# Access Compliance Report

## Public Rights-of-Way

### (Curb Ramps)

Intersection ID: 51668	Main Street: BROWNE_RD	Cross Street: SWEETBRIAR_RIDGE_DR	Location: W
ADA ID: AD8A4DE104C6	Ramp Type: Para	Initial Pass/Fail: Fail	Overall Compliance: No
Severity Score: 1.25			
Codes/Mitigation Info/Possible Solution		Field Measurements/Component Compliance

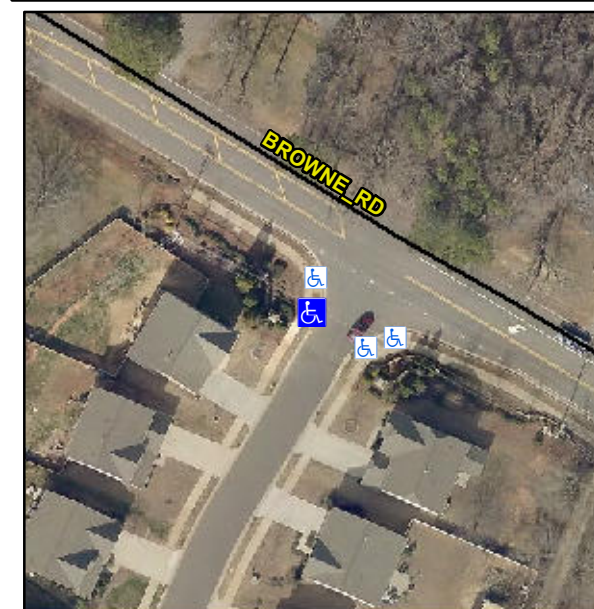
**LT RP < 5%**

**R304.5.3**

Compliance	Description	Data	Compliance	Description	Data
N/A	Ramp Length LT (in)	61.0	N/A	Ramp Length RT (in)	45.0
Yes	Ramp Width LT (in)	61.0	Yes	Ramp Width RT (in)	59.0
Yes	Ramp Slope LT (%)	4.3	Yes	Ramp Slope RT (%)	5.5
Yes	Ramp XSlope LT (%)	1.8	No	Ramp XSlope RT (%)	2.4
N/A	Landing Length (in)	N/A	N/A	DWS Provided?	N/A
N/A	Landing Width (in)	N/A	N/A	DWS Contrast?	N/A
N/A	Landing Slope (%)	N/A	N/A	DWS Length (in)	N/A
N/A	Landing X Slope (%)	N/A	N/A	DWS Full Width?	N/A
N/A	Landing Curb? (Y/N)	N/A	N/A	DWS Offset (in)	N/A
N/A	Shared Landing?	N/A			
N/A	Gutter Ponding?	N/A	N/A	Gutter Slope (%)	N/A
N/A	Gutter Lip Ht (in)	N/A	N/A	Gutter X Slope (%)	N/A
N/A	Painted X Walk1?	No	N/A	Painted X Walk2?	N/A
	X Walk 1 Direction	To SE		X Walk 2 Direction	N/A
N/A	X Walk 1 Width (in)	N/A	N/A	X Walk 2 Width (in)	N/A
	X Walk 1 Slope (%)	1.1		X Walk 2 Slope (%)	N/A
	X Walk 1 X Slope (%)	1.3		X Walk 2 X Slope (%)	N/A
N/A	Ramp inside XWalk1?	N/A	N/A	Ramp inside XWalk2?	N/A

**Remove & Replace Entire Ramp.**
